**PLANNED UNIT DEVELOPMENT &
SUBDIVISION STAFF REPORT**

Date: May 6, 2004

DEVELOPMENT NAME Heron Lakes Subdivision, Phase One, Revised Lot 32

SITE PLAN

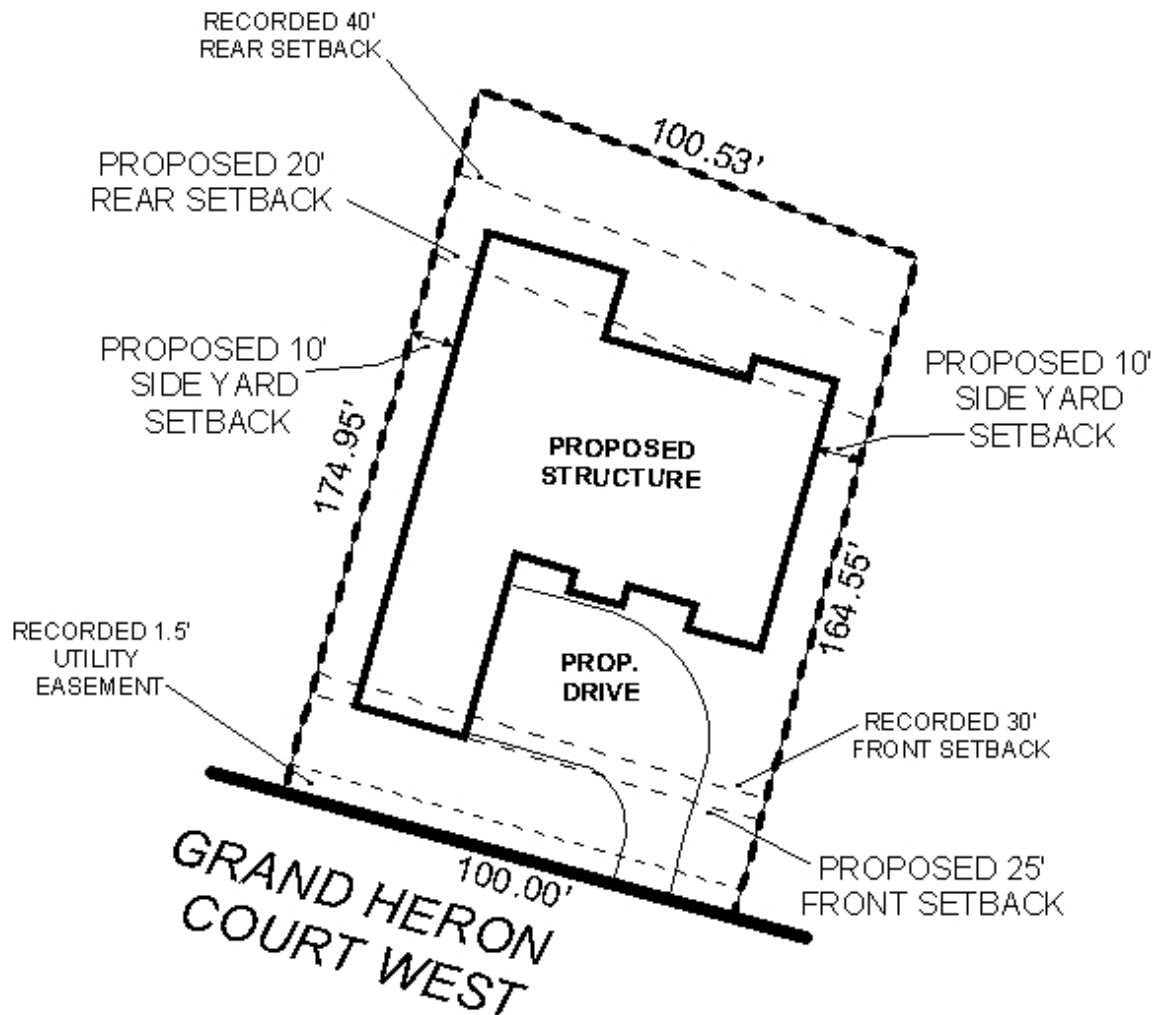
**ENGINEERING
COMMENTS** Engineer to provide verification that existing stormwater system, including designed and constructed detention, can accommodate increased coverage. Must comply with all stormwater and flood control ordinances. Any work performed in the right of way will require a right of way permit.

The proposed setback lines (25-feet along the front and 20-feet along the rear) comply with the minimum setback requirements of both the Zoning Ordinance and Subdivision Regulations and thus could be considered appropriate for the site. Furthermore, there have been numerous requests for modified front and rear yard setbacks in Heron Lakes.

Planned Unit Development: Based upon the preceding, this application is recommended for approval subject to the following condition: 1) that the Engineer provide verification that the existing stormwater system, including designed and constructed detention, can accommodate the increased site coverage.

Subdivision: The plat meets the minimum requirements of the Subdivision Regulations and is recommended for Tentative Approval subject to the following condition: 1) that the Engineer provide verification that the existing stormwater system, including designed and constructed detention, can accommodate the increased site coverage.
